Apalis iMX8X

Errata Document

Figure 1 Possible voltage divider workaround on Ixora V1.2

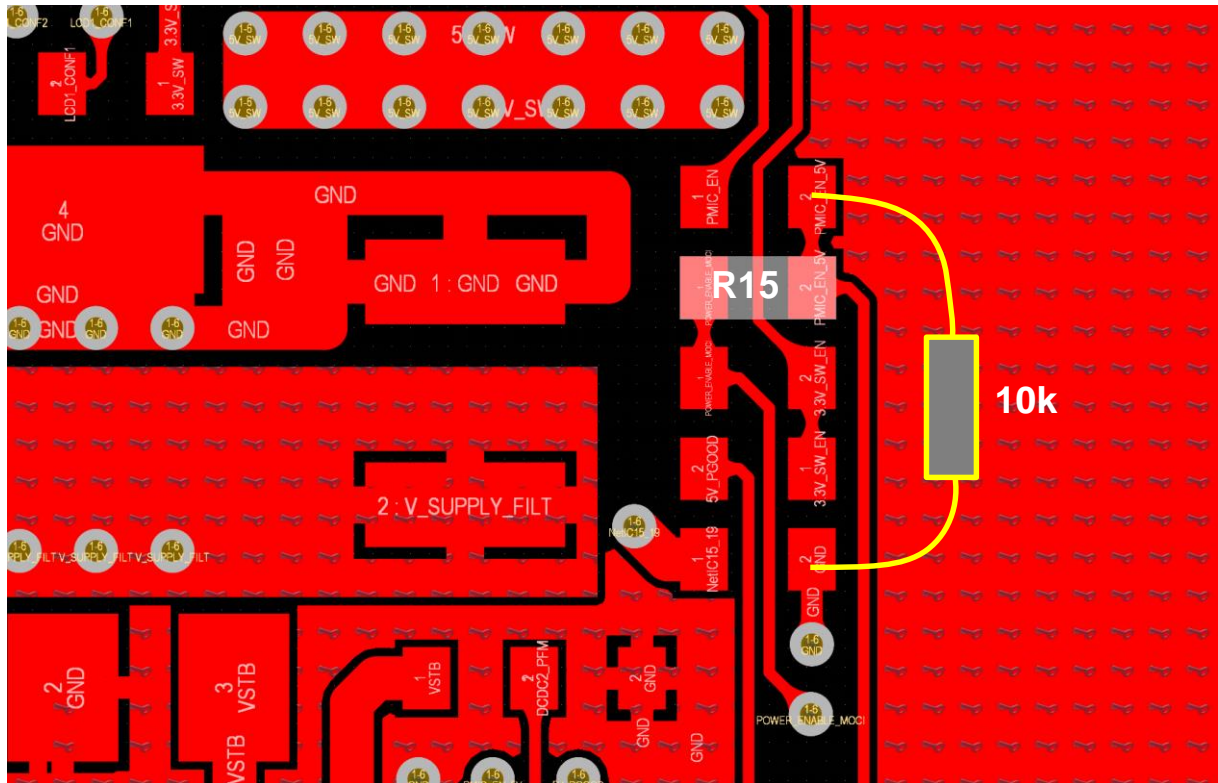
Depending on the carrier board and the amount of backfeeding, the POWER_ENABLE_MOCI might not go low enough to turn off the peripheral voltage rails in the shutdown state.

The POWER_ENABLE_MOCI signal is intended to be used for switching the peripheral voltage rails on the carrier board, like the 5V_SW and 3.3V_SW on the Ixora. Depending on the amount of backfeeding over the interface signals from the carrier board to the Apalis iMX8X module, the POWER_ENABLE_MOCI signal can remain between 1.0V and 1.4V in module shutdown. Depending on the carrier board circuit, this can be too high for turning off the peripheral voltage rails.

For example, on the Ixora V1.2, a different buck converter for the 5V_SW is used than on the previous versions. The threshold voltage for the enable signal is lower on the new buck converter. Depending on the backfeeding level, the 5V_SW buck converter does not get disabled in the shutdown state. The Ixora V1.0 and V1.1 are not affected by this issue since they have been using a different buck converter with a higher threshold.

Add a circuit to the carrier board for increasing the POWER_ENABLE_MOCI threshold voltage to between 2.0V and 2.5V. This could be achieved by adding a comparator or similar circuit. Such a solution is implemented in the V1.3 revision of the Ixora.

A simple voltage divider added to the POWER_ENABLE_MOCI signal can shift the voltage levels. Important: make sure that the minimum input voltage for enabling the buck converter is still guaranteed. With the AOZ2260 buck converter (which is used on Ixora V1.2), a 10k/10k voltage divider can be a suitable option. For patching such a divider, replace R15 with a 10k 0603 resistor and add another 10k resistor from the PMIC_EN_5V signal to the ground.
